**WHEELING PLAN COMMISSION
THURSDAY, JANUARY 25, 2018 6:30 P.M.**

REQUEST FOR PLAN COMMISSION ACTION
STAFF PROJECT REVIEW

RE: **Docket No. SCBA 18-3**
Boston Fish Market
412 N. Milwaukee Avenue
Appearance Approval of Wall & Freestanding Signs

RE: Docket Nos. 2017-18 and SCBA 18-4
Shri Swaminarayan Temple
397 Northgate Parkway
(2017-18) Special Use-Site Plan Amendment to Allow for a
Building Addition
(SCBA 18-4) Appearance Approval of a Freestanding Sign

EAST ELEVATION

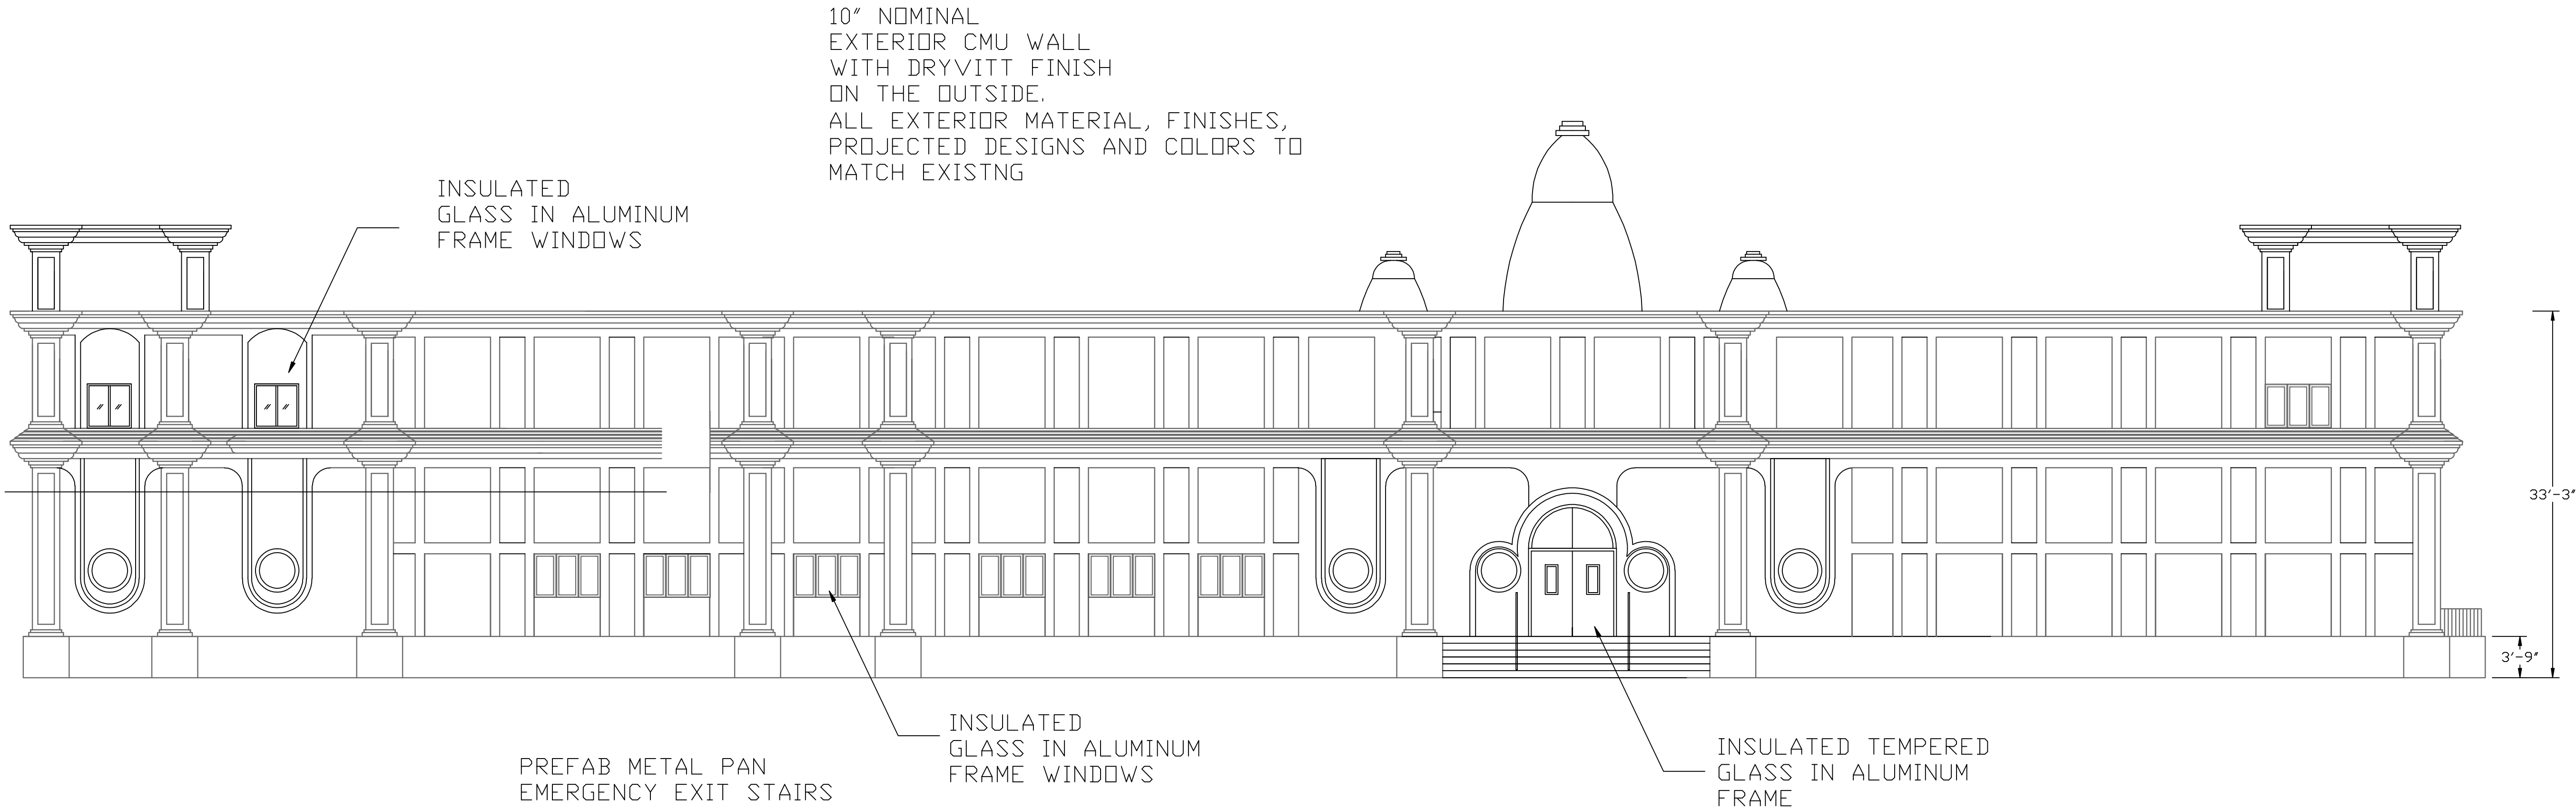
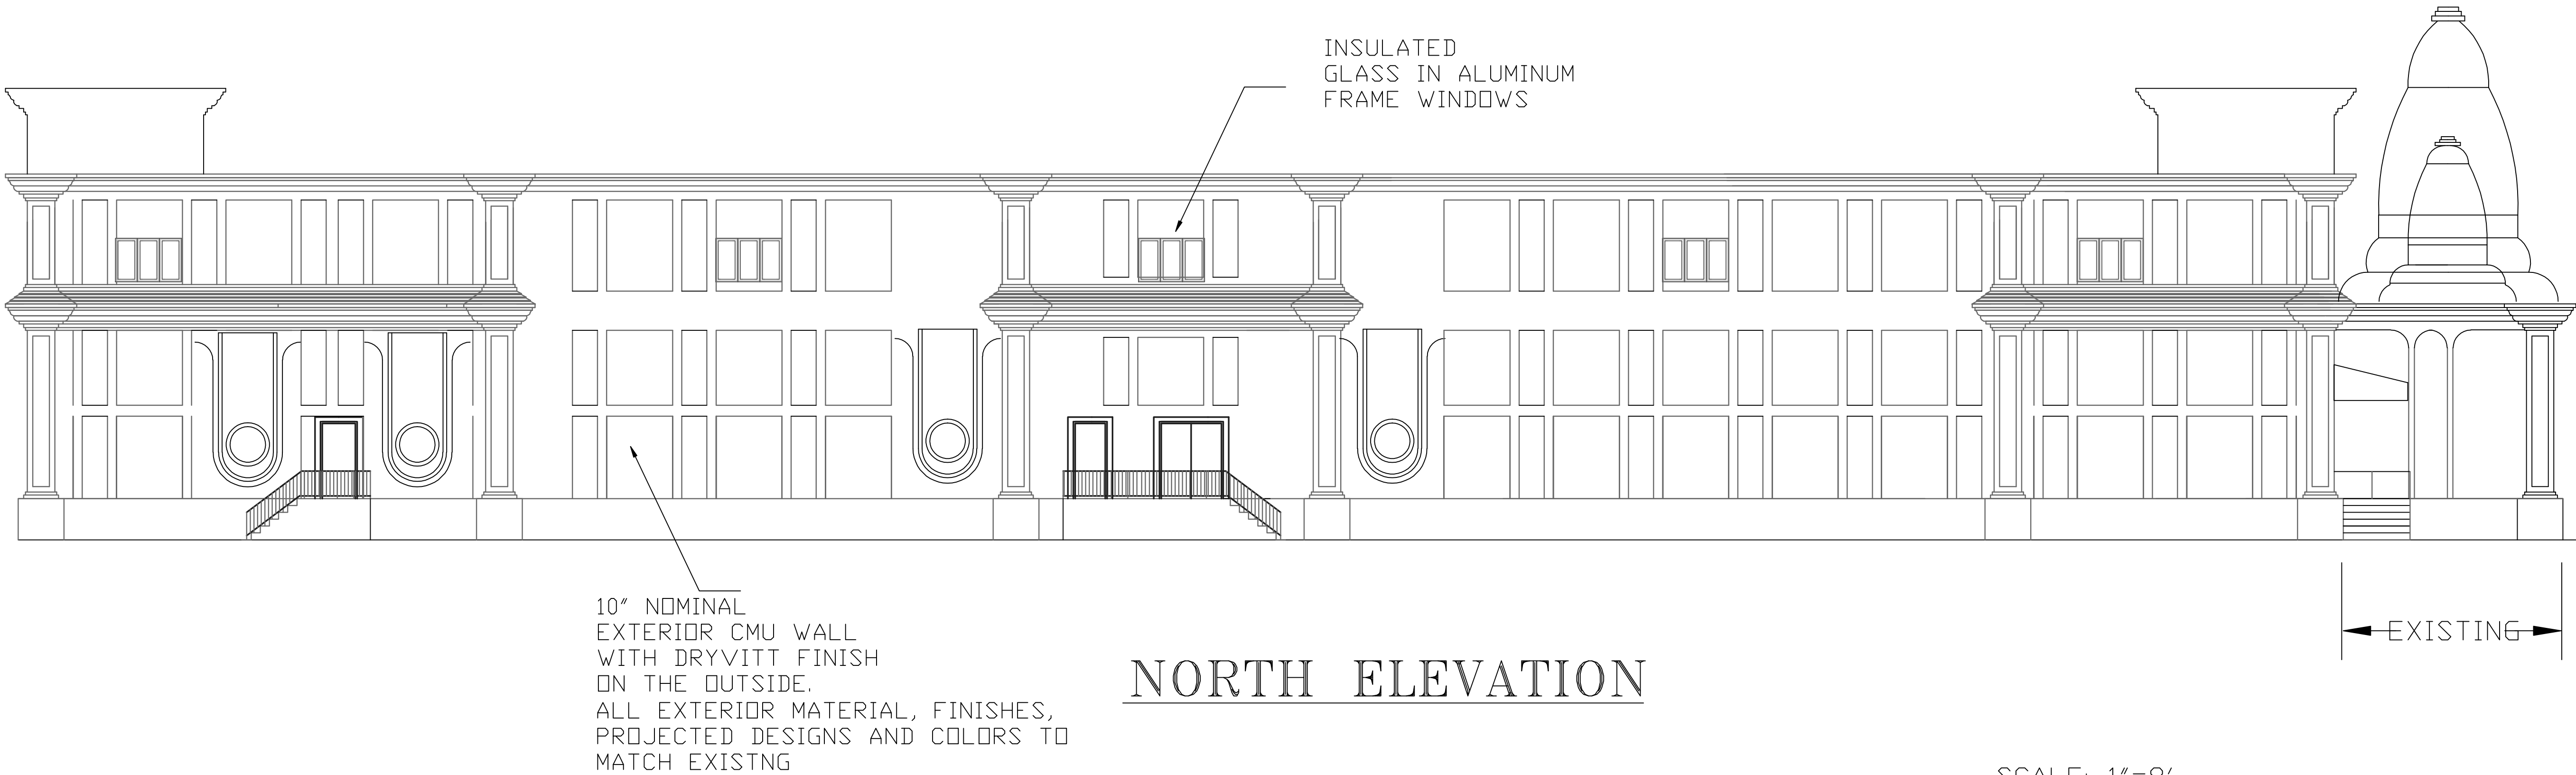
HVAC/Mechanical Components Screened: There are some 7'10" parapets on the elevation plans that may serve more than an aesthetic purpose. They may also screen rooftop mechanical units. The Plan Commission may wish to discuss mechanical unit screening with the petitioner.

MONUMENT SIGN
LANDSCAPE PLAN

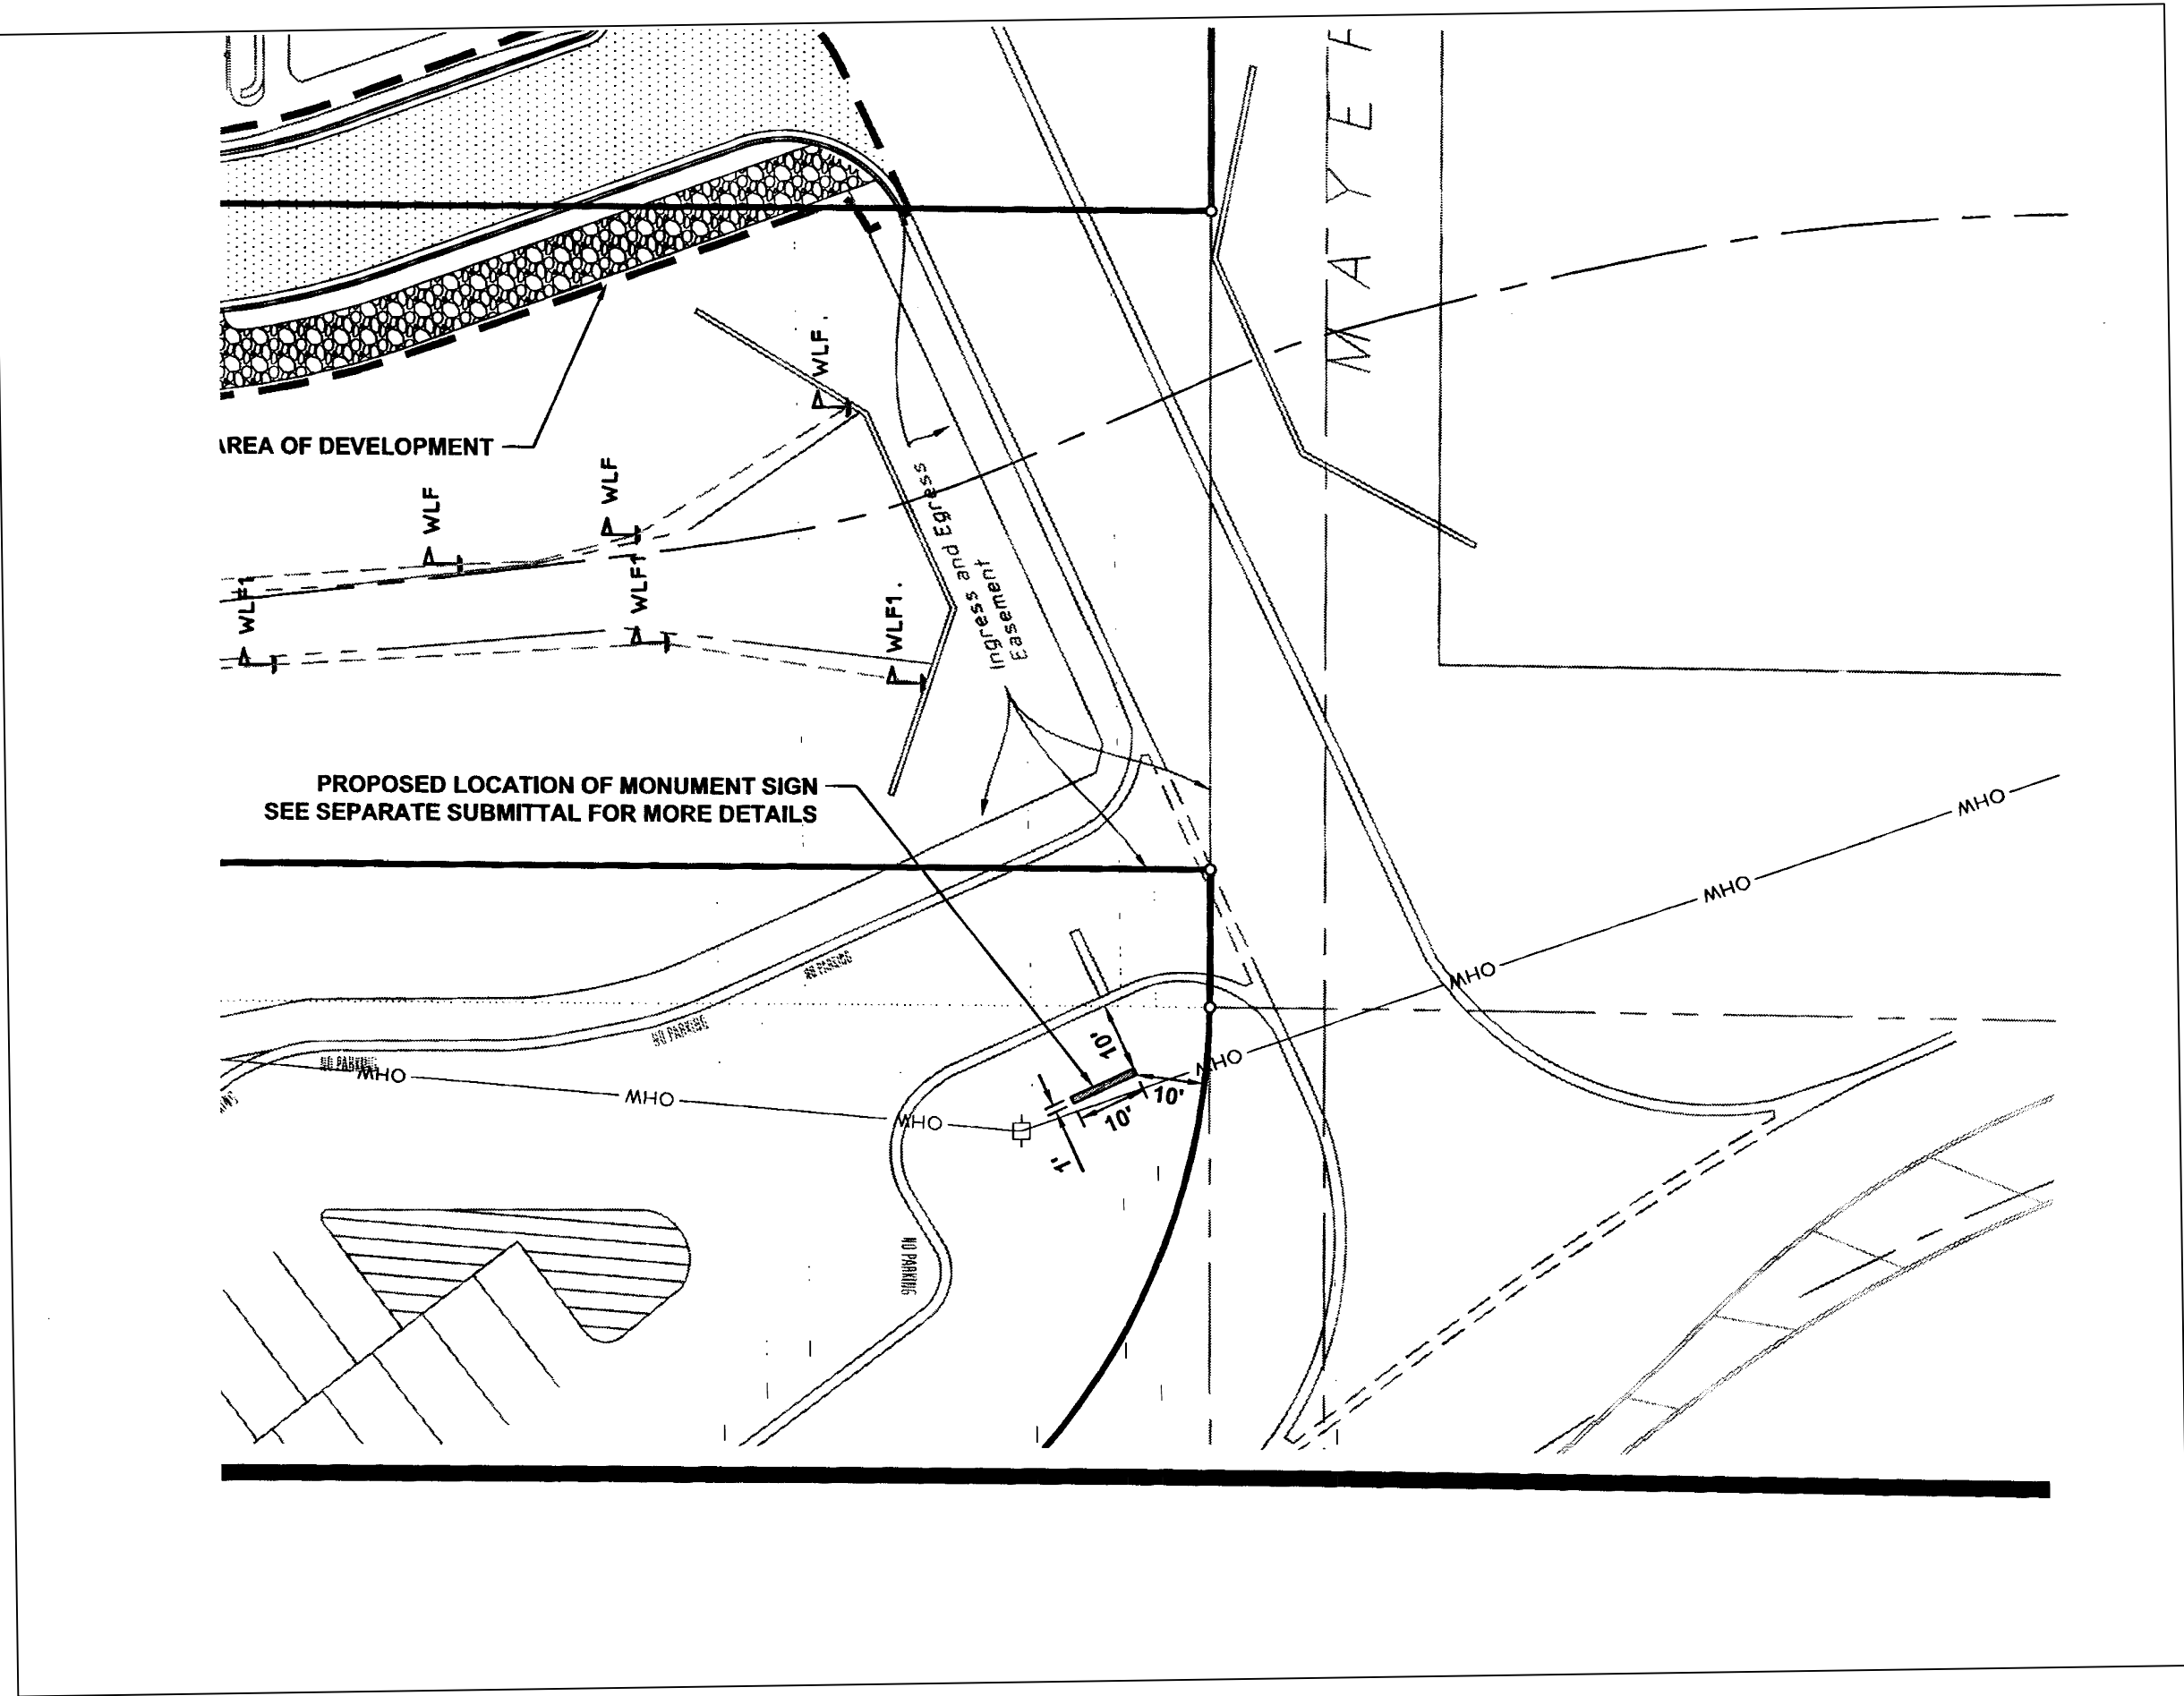
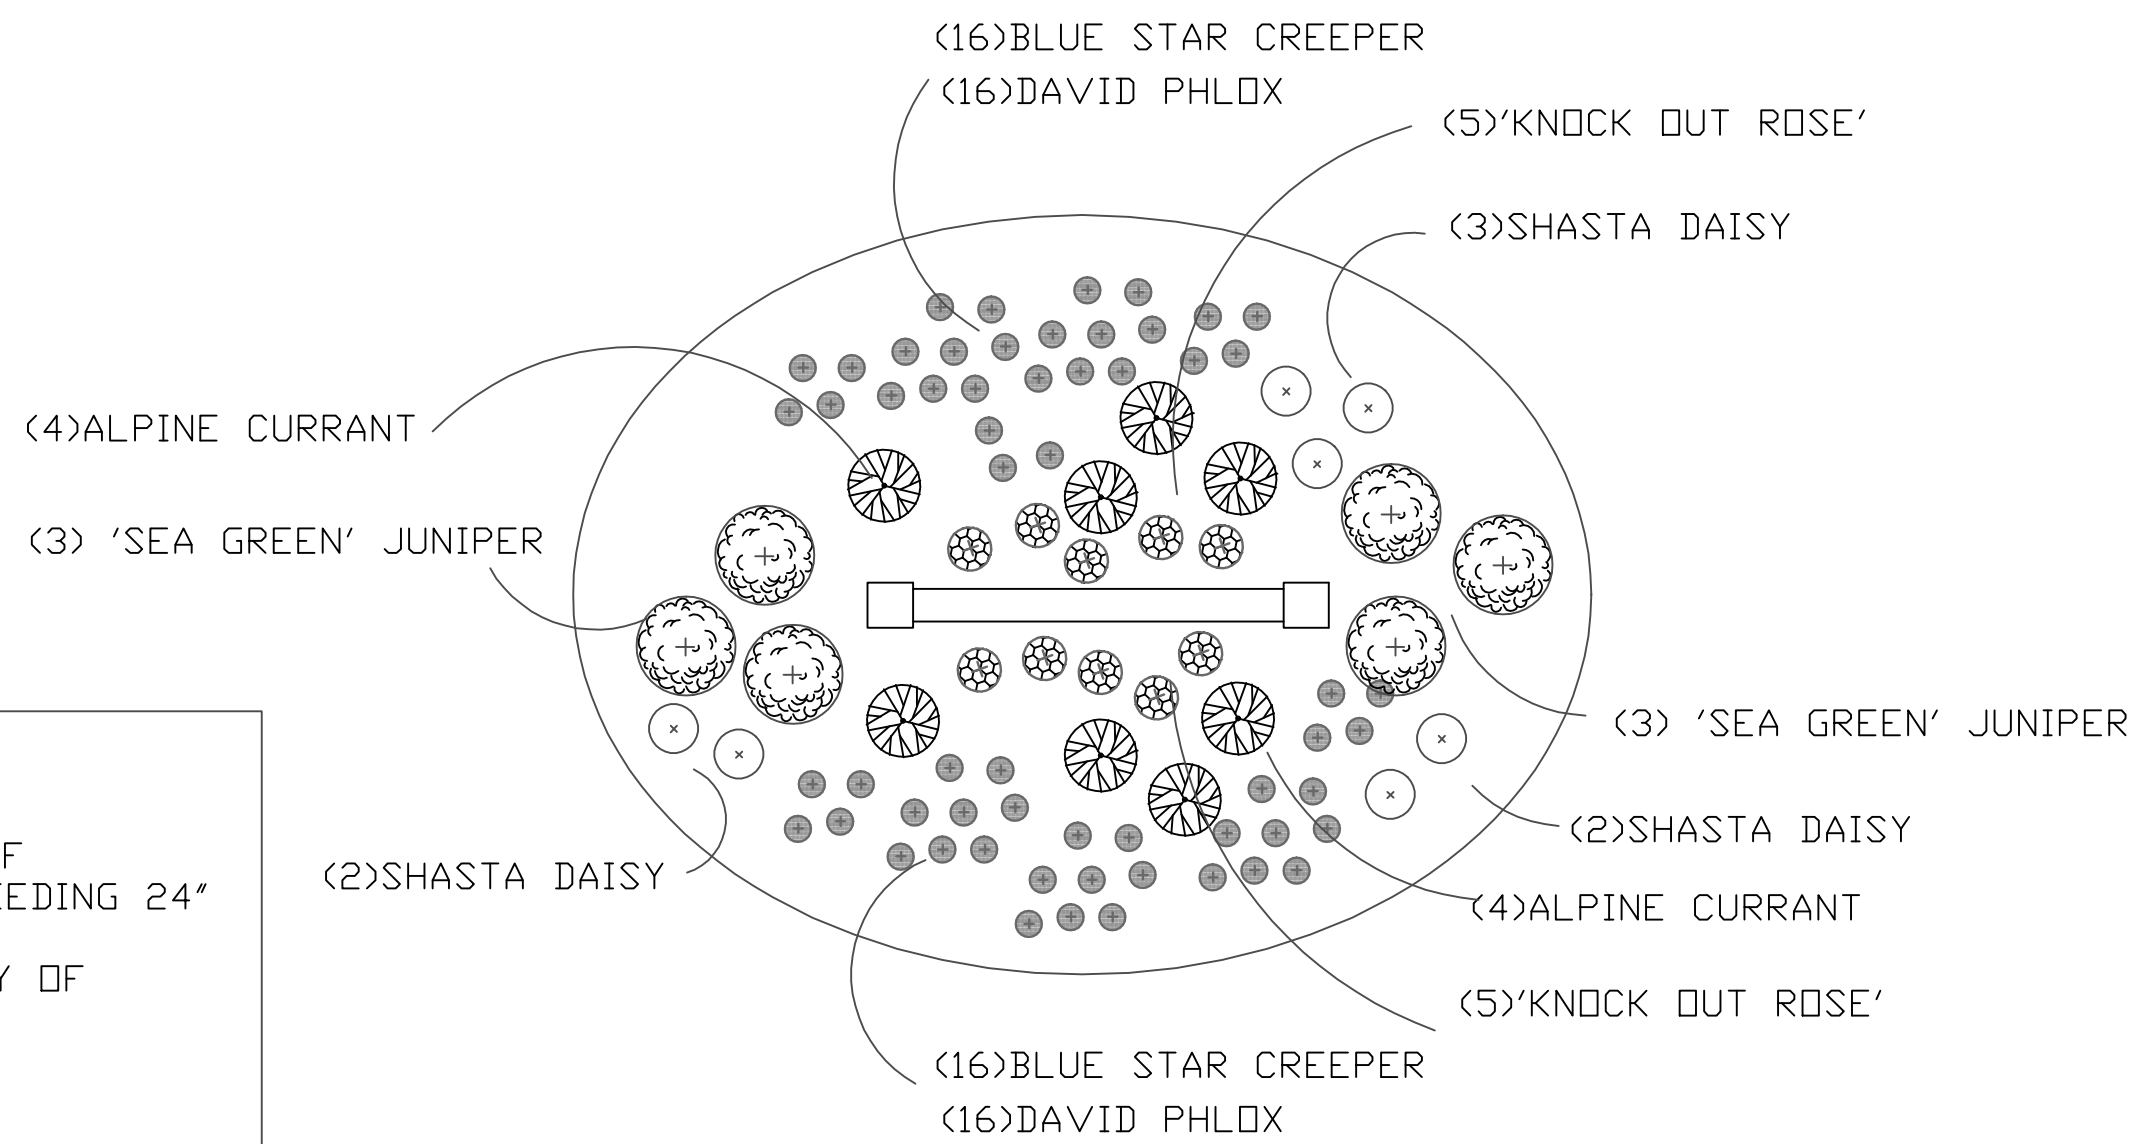
Landscaping: A landscape plan is proposed for the freestanding sign. The proposed landscaped area is approximately 240 square feet, which is over four times the size of the required landscaped area. The proposed landscape plan meets the species mix requirements of the Sign
